YMP YUCCA MOUNTAIN PROJECT	**Model** **Error Resolution Document** *Complete only applicable items.*	QA: QA Page 1 of 2

1. Document Number:	MDL-WIS-PA-000005	**2. Revision/Addendum:**	Rev 00 and AD 01	**3. ERD:**	ERD 05
4. Title:	Total System Performance Assessment Model/Analysis for the License Application				
5. No. of Pages Attached:	24

An impact analysis was performed for TSPA-LA Rev00 [DIRS 178871] and the addendum [DIRS 183478]. For Rev00, a total of 12 controlled documents were found, however, none of the documents are using the TSPA-LA as a direct input, nor do they reference any of the sections being revised in this ERD. For the Addendum, 8 controlled documents were found, of these, two use the Addendum as a direct input but are affected only by changes in this ERD related to CR 12543 (ANL-WIS-MD-0000027 Rev 00 and ANL-DS0-NU-000001 Rev 00). It should also be noted that CAL-DN0-NU-000002 Rev 00C uses the localized corrosion DTN (CR 12543) as direct input, and will also be affected. The SAR has been evaluated for changes needed due to this ERD and will require minor modifications through the LCR process. These changes will have no effect on the results and conclusions pre

Figure B-1. Road Map of TSPA-LA Model Data Tracking Numbers

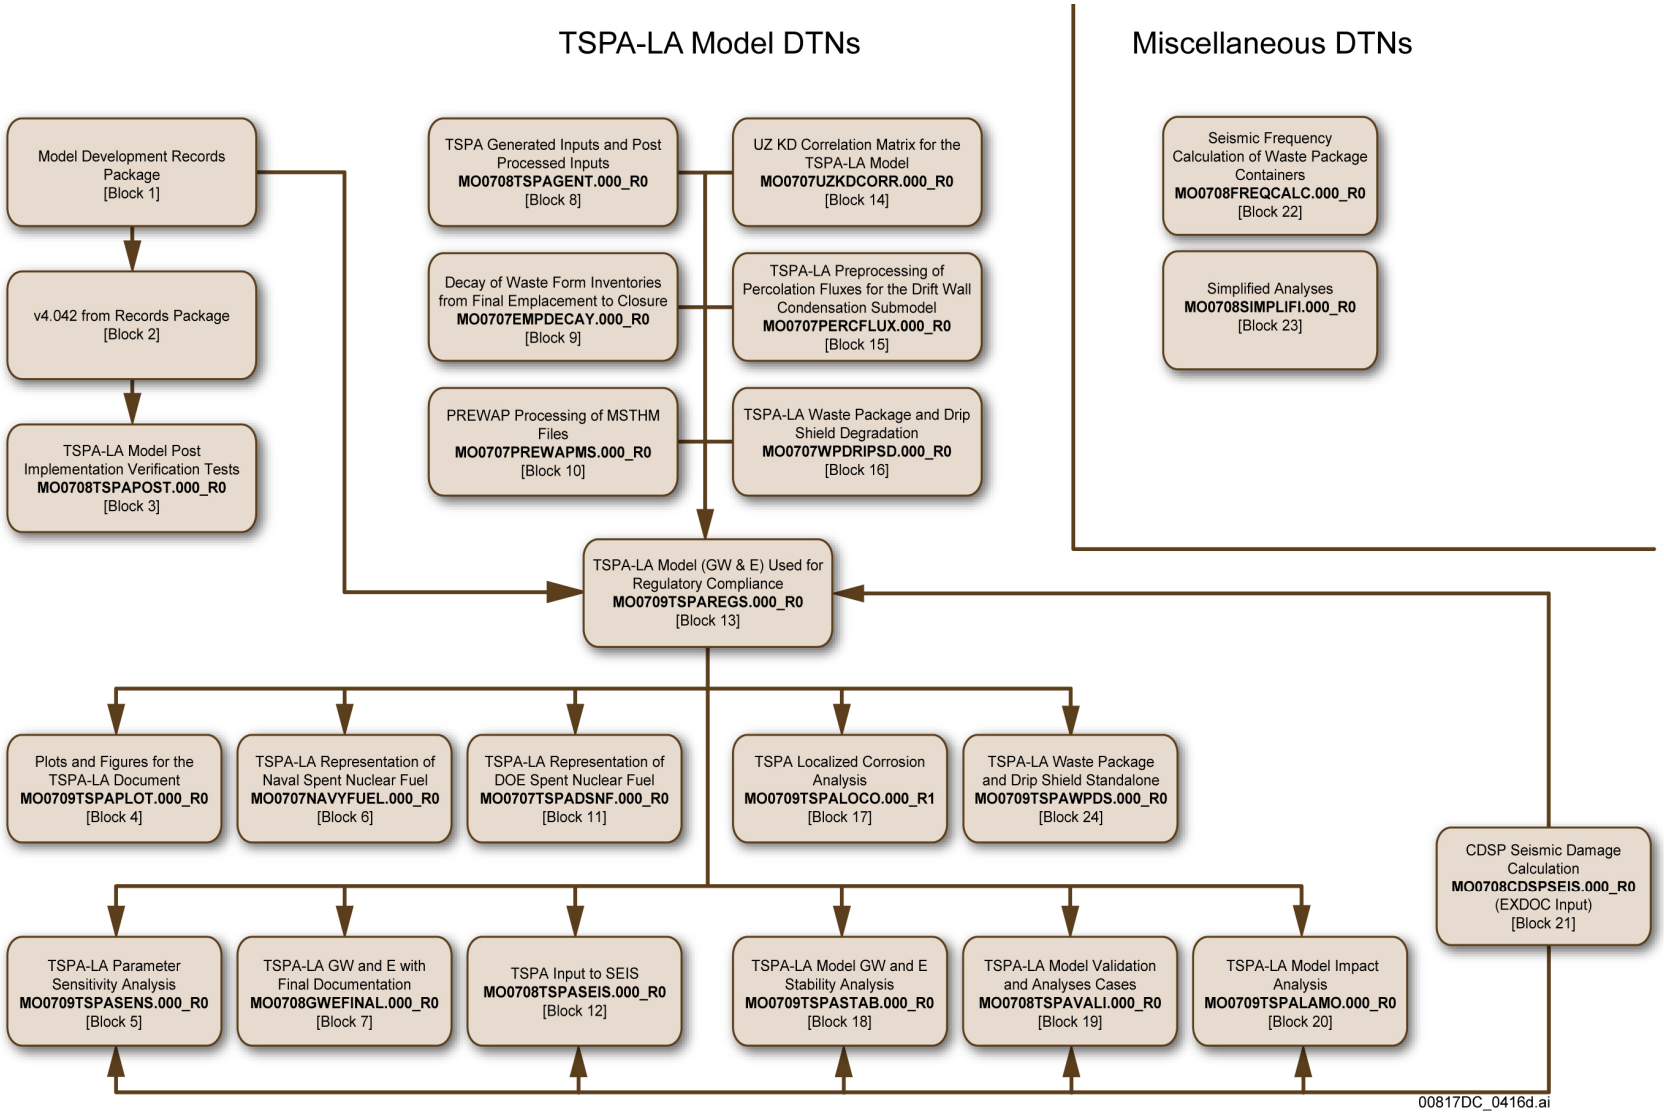
Replace Figure B-1 in order to revise the DTN reference in Block 17 (page B-9):

Reference Figure B-1, Block 17—This DTN contains the GoldSim runs that are used to confirm that localized corrosion is addressed by the Compliance Model that is documented in output DTNs MO0709TSPAREGS.000 [DIRS 182976] and MO0710TSPAWO.000 [DIRS 183752].
